Access Compliance Report

Public Rights-of-Way

Intersection ID: 50600	Main Street: BENDING_BRANCH_RD	Cross Street: HEARTLEAF_RD	Location:	N
ADA ID: F3383D45247A	Ramp Type: Perp	Initial Pass/Fail: Fail	Overall Compliance: No	Severity Score: 12.5
Codes/Mitigation Info/Possible Solution		Field Measurements/Component Compliance

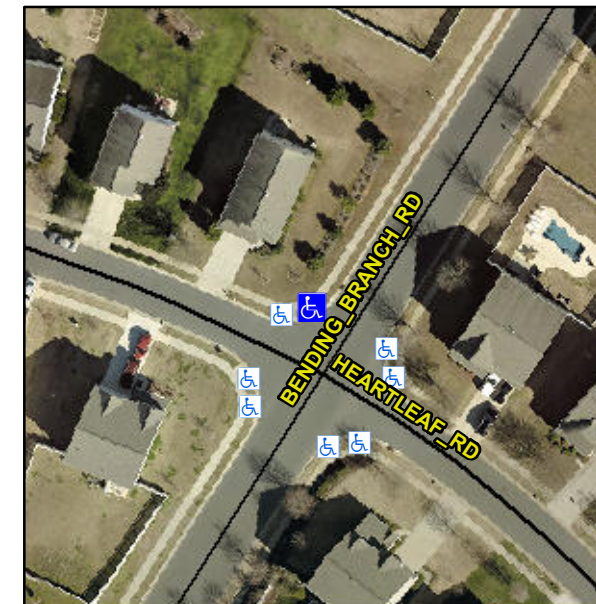
Not Found, R304.5.3

Compliance	Description	Data	Compliance	Description	Data
N/A	Ramp Length (in)	47.0	Yes	Ramp Slope (%)	7.1
Yes	Ramp Width (in)	48.0	No	Ramp XSlope (%)	5.1
N/A	Flare Type LT	N/A	N/A	Flare Type RT	N/A
N/A	Flare Slope LT (%)	N/A	N/A	Flare Slope RT (%)	N/A
N/A	Flare Traversable LT?	N/A	N/A	Flare Traversable RT?	N/A
N/A	Landing Length (in)	N/A	N/A	DWS Provided?	N/A
N/A	Landing Width (in)	N/A	N/A	DWS Contrast?	N/A
N/A	Landing Slope (%)	N/A	N/A	DWS Length (in)	N/A
N/A	Landing X Slope (%)	N/A	N/A	DWS Full Width?	N/A
N/A	Landing Curb? (Y/N)	N/A	N/A	DWS Offset (in)	N/A
N/A	Shared Landing?	N/A			
N/A	Gutter Ponding?	N/A	N/A	Gutter Slope (%)	N/A
N/A	Gutter Lip Ht (in)	N/A	N/A	Gutter X Slope (%)	N/A
N/A	Painted X Walk1?	No	N/A	Painted X Walk2?	N/A
	X Walk 1 Direction	To SE		X Walk 2 Direction	N/A
N/A	X Walk 1 Width (in)	N/A	N/A	X Walk 2 Width (in)	N/A
	X Walk 1 Slope (%)	2.7		X Walk 2 Slope (%)	N/A
	X Walk 1 X Slope (%)	4.2		X Walk 2 X Slope (%)	N/A

Remove & Replace Entire Ramp.
